VALE CONSULTANCY
18529-SK01
GROUND FLOOR PLAN
SHOWING STRUCTURE
ABOVE (NOT TO SCALE)

VALE CONSULTANCY
18529- SK02
FIRST FLOOR PLAN
SHOWING STRUCTURE
ABOVE (NOT TO SCALE)

VALE CONSULTANCY
18529-SK03
SIDE ELEVATION -
SHOWING STEEL PORTAL
FRAME IN REAR
BUILDING (NOT TO SCALE)

VALE CONSULTANCY
18529 - SK05
SIDE ELEVATION -
SHOWING DEFECT REMEDIES
(NOT TO SCALE)

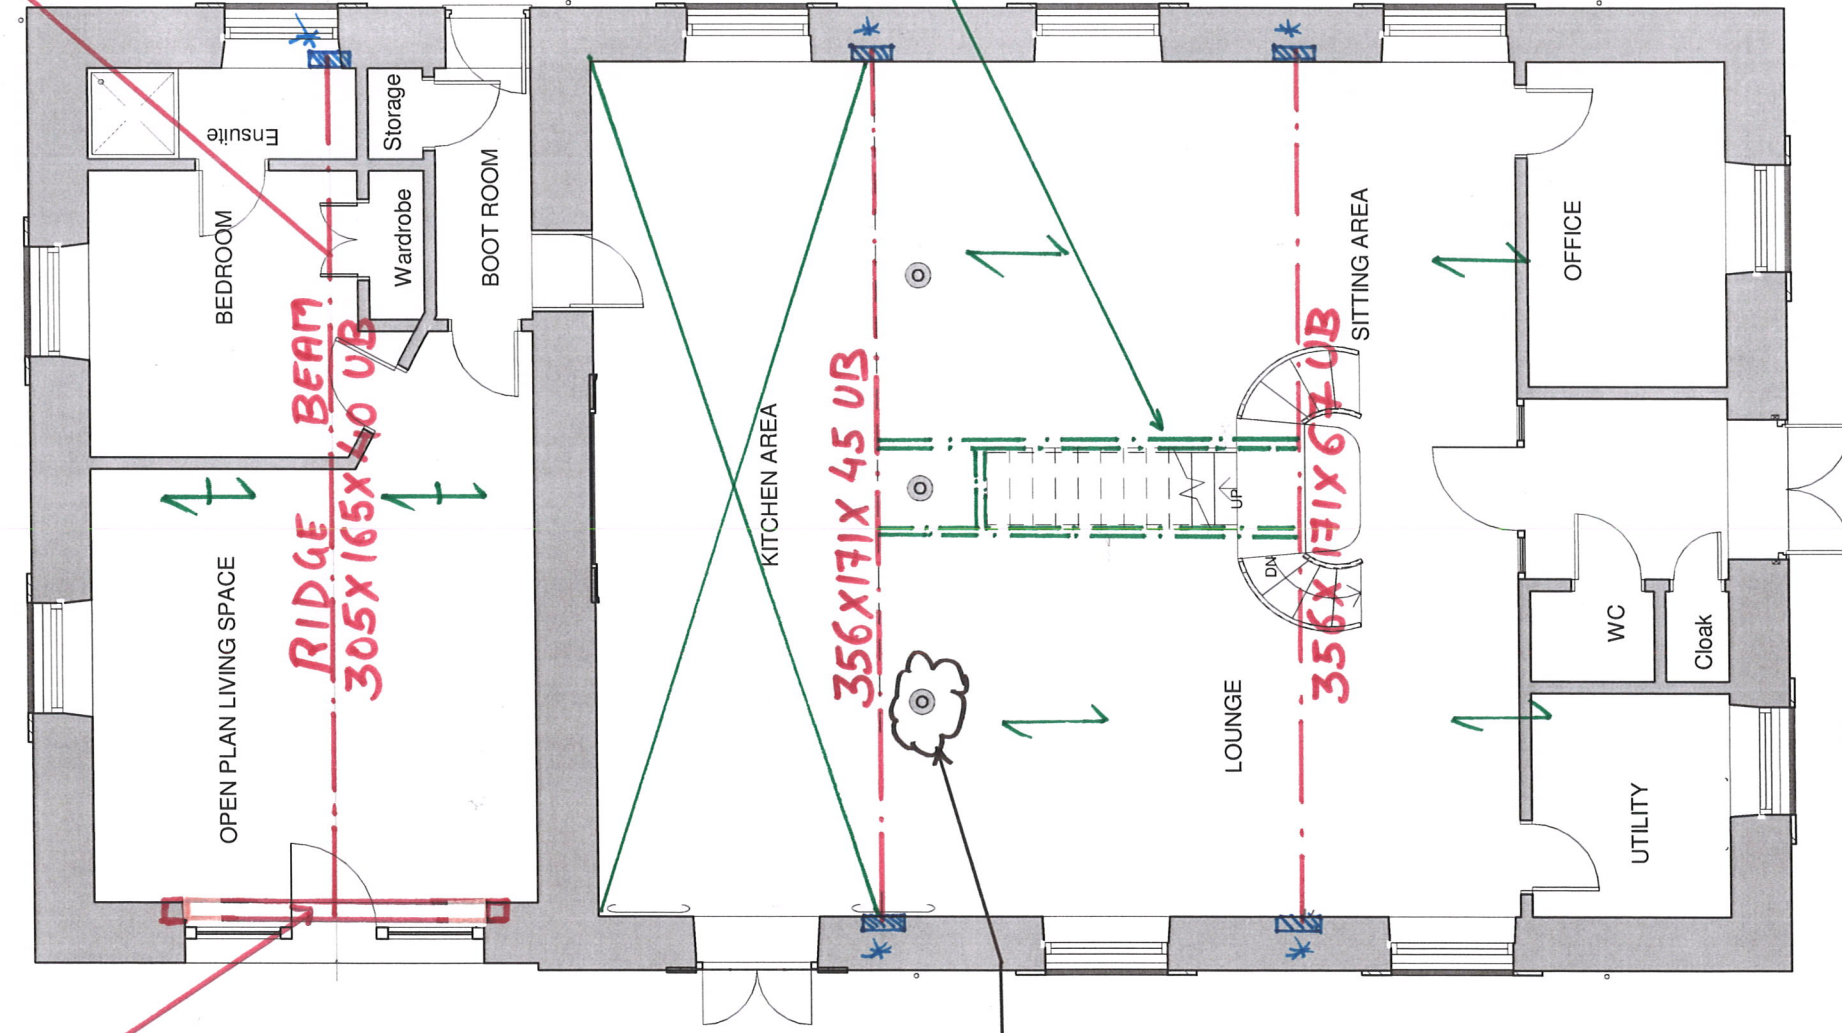
RIDGE STEEL REQUIRED
 IF FULLY VAULTED
 ROOF ZONE PREFERRED,
 OTHERWISE TIMBER
 TRUSSES CAN REMAIN
 SUBJECT TO ADDITIONAL
 INSPECTION ONCE
 ROOF OPENING WORKS
 HAS BEEN DONE.

COLUMNS
 FOR AESTHETIC
 PURPOSE ONLY

→ CONTRACTOR TO CHECK FOR
 SUITABILITY OF EXISTING
 STONWORK FOR STEEL BEARING.
 IF UNSUITABLE, COLUMNS MAY
 BE REQUIRED.

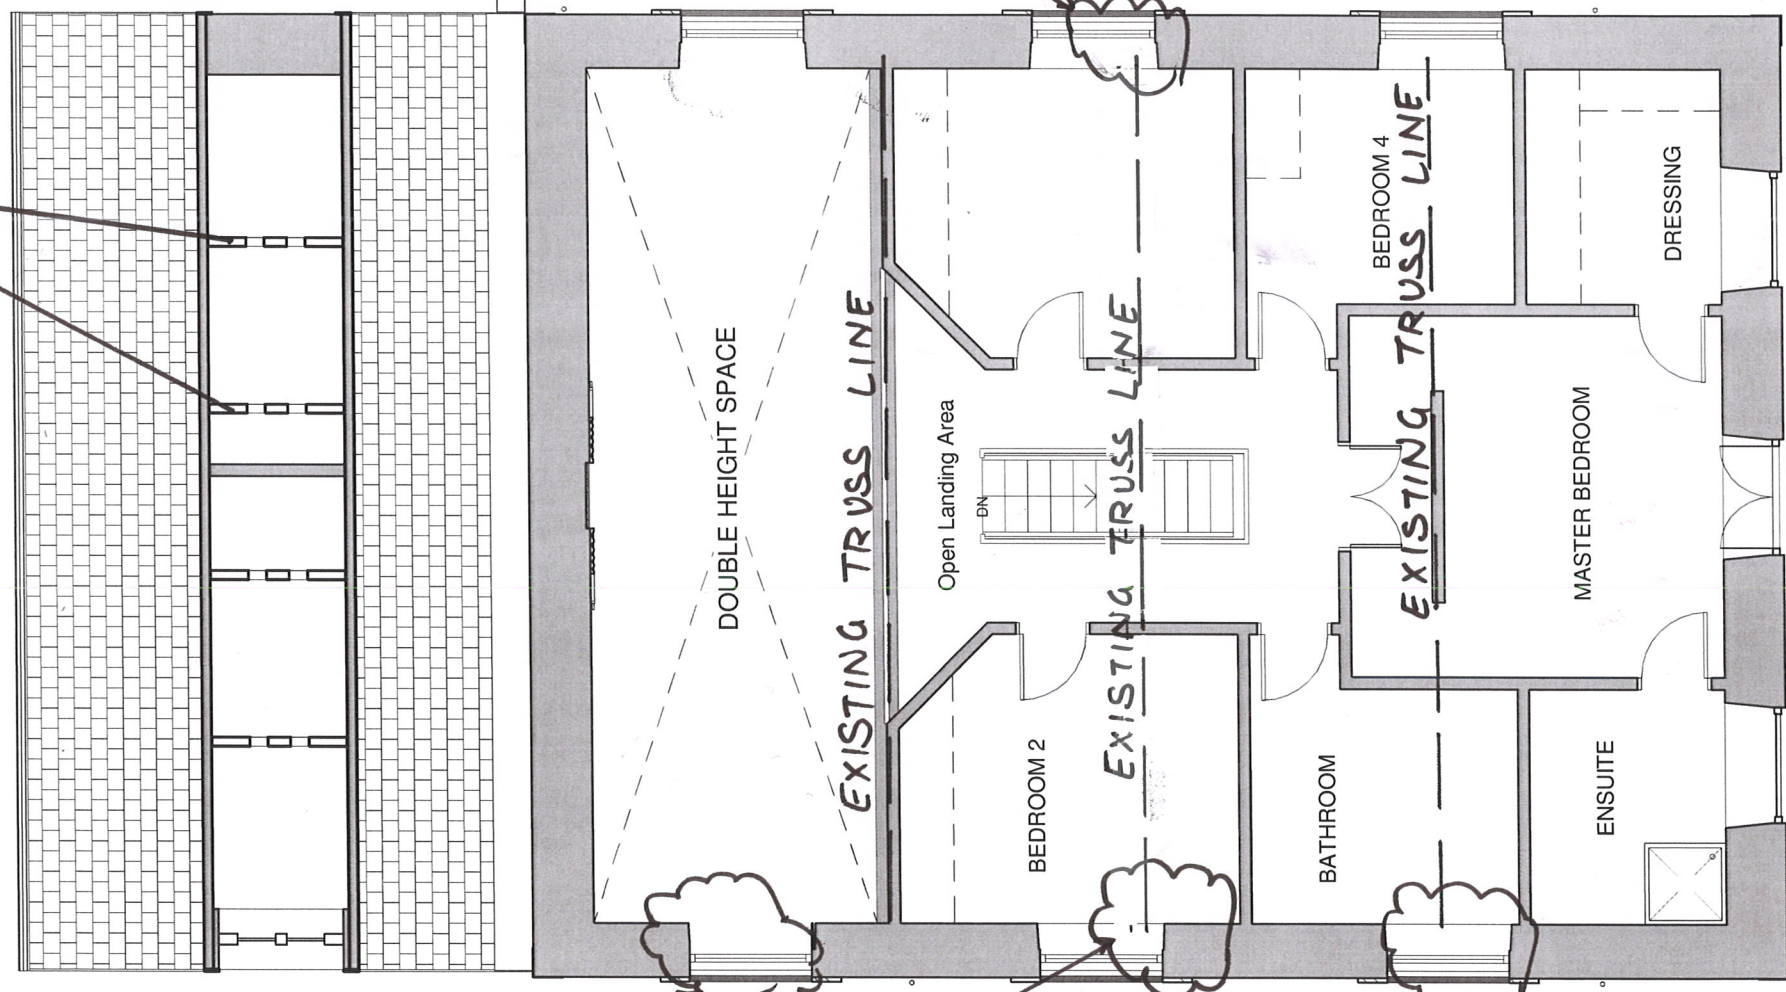
EXISTING TRUSSES
ARE IN GOOD CONTION,
COULD BE RETAINED
(OR USE RIDGE BEAM
AS SHOWN IN SK01)
FURTHER OPENING OF
ROOF REQUIRED AND
RAFTERS TO BE
CHECKED.

PLASTER TO BE
REMOVED,
LINTEL INSPECTED
AND REPLACED, IF
NECESSARY.

MOVEMENT NOTED-
FROM INSPECTION
IT IS POSSIBLE EXISTING
LINTEL IS DEFLECTED
CAUSING THE TRUSS
TO DROP.
FURTHER OPENING UP
OF ROOF REQUIRED.

PLASTER TO BE
REMOVED,
LINTEL INSPECTED
AND REPLACED
IF NECESSARY.

MINOR SIGNS OF
MOVEMENT,
LINTEL TO BE
REPLACED IF
NECESSARY, FURTHER
OPENING OF ROOF
REQUIRED.

VALE CONSULTANCY
18529-SK04
FRONT ELEVATION-
SHOWING DEFECTS
REMEDIES (NOT TO SCALE)

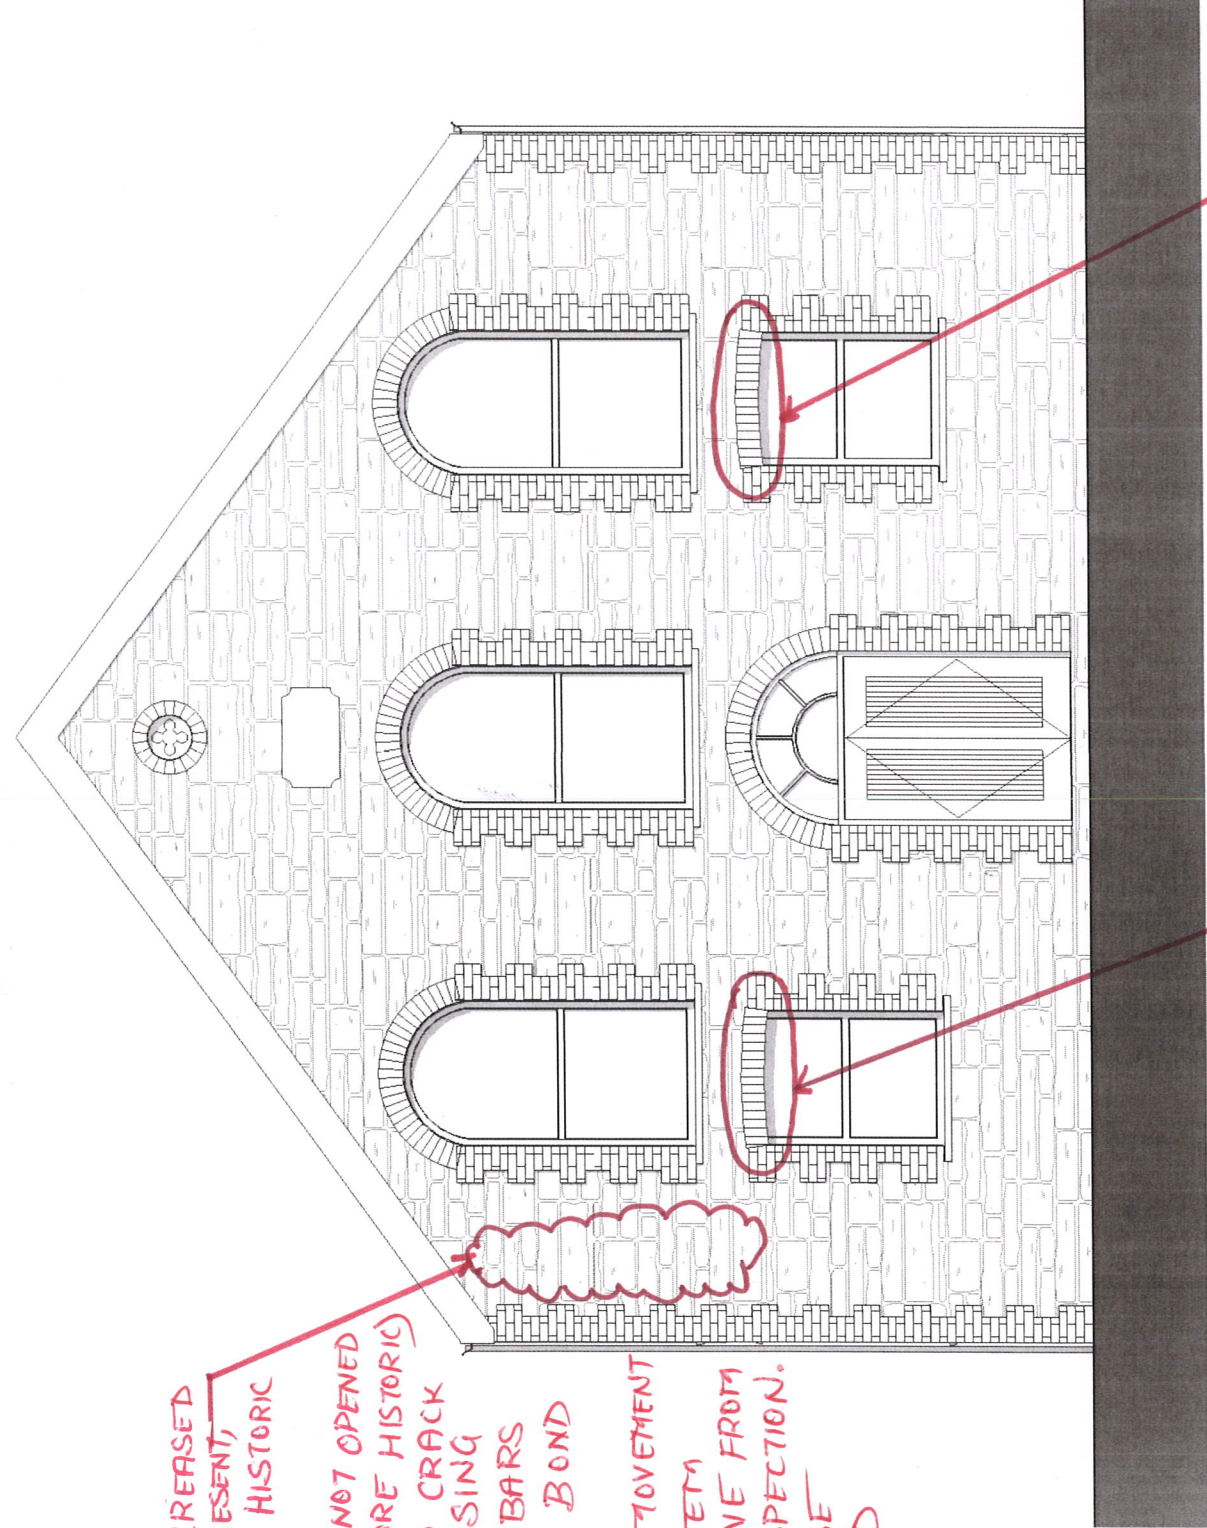
LINE OF INCREASED
MORTAR PRESENT,
INDICATING HISTORIC
CRACK.
(CRACK HAS NOT OPENED
UP THEREFORE HISTORIC)
RECOMMEND CRACK
STITCHING USING
HELIFIX HELIBARS
TO SUITABLY BOND
STONEWORK.
STONEWORK MOVEMENT
DOESN'T SEEM
PROGRESSIVE FROM
INITIAL INSPECTION.
AREA TO BE
MONITORED

BOWING / MOVEMENT OF
STONEWORK ABOVE WINDOW
PRESENT.
LINTEL BELOW HAS DROPPED
AND NEEDS TO BE REPLACED.
STONEWORK ABOVE TO BE
TAKEN OUT AND REBUILT.

BOWING / MOVEMENT
OF STONEWORK ABOVE
WINDOW PRESENT.
LINTEL ABOVE HAS
DROPPED AND NEED
TO BE REPLACED.
STONEWORK ABOVE TO
BE TAKEN OUT AND
REBUILT.

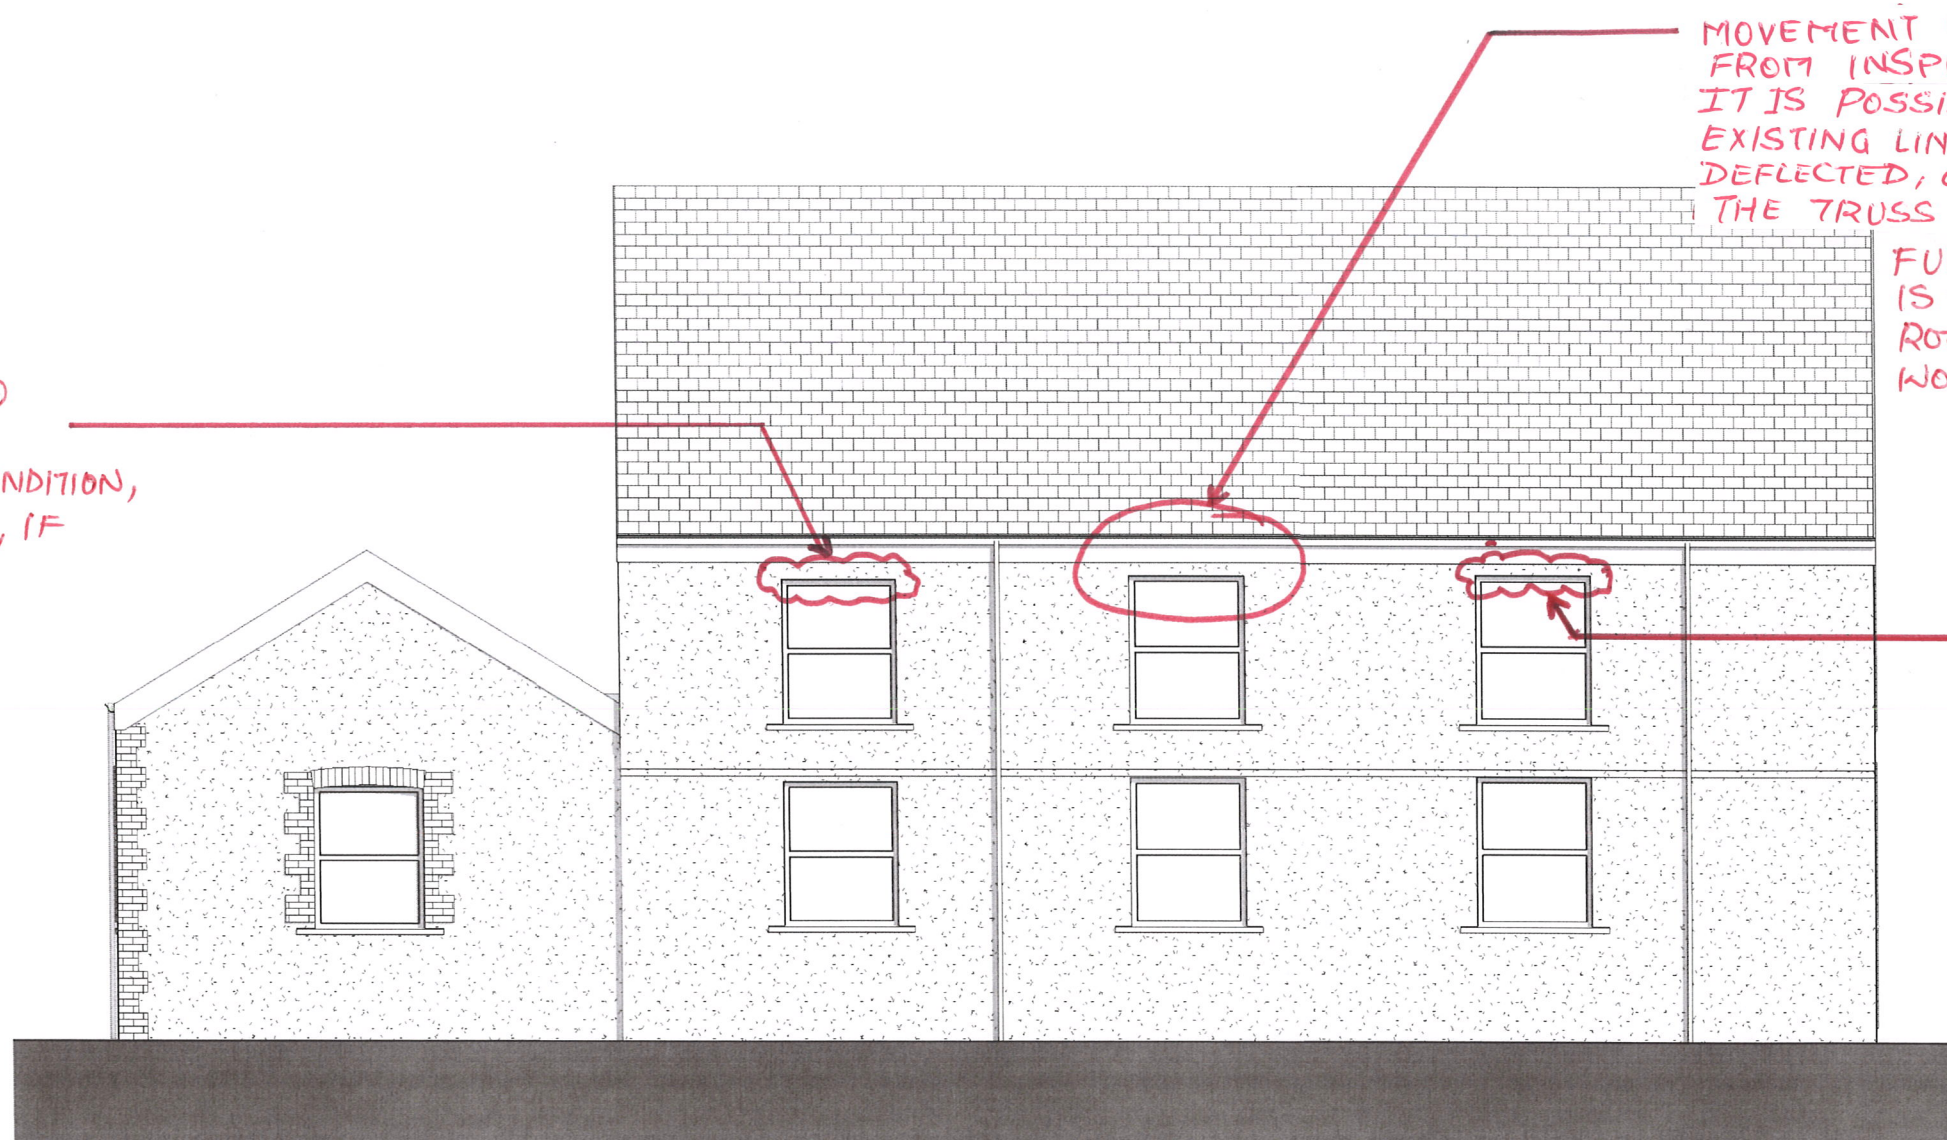
PLASTER WORK TO
BE REMOVED TO
ASSESS LINTEL CONDITION,
TO BE REPLACED, IF
REQUIRED.

MOVEMENT NOTED -
FROM INSPECTION
IT IS POSSIBLE THAT
EXISTING LINTEL IS
DEFLECTED, CAUSING
THE TRUSS TO DROP.

FURTHER INSPECTION
IS REQUIRED AFTER
ROOF OPENING UP
WORK HAS BEEN DONE.

PLASTER WORK TO
BE REMOVED TO
ASSESS LINTEL CONDITION,
TO BE REPLACED IF
REQUIRED.
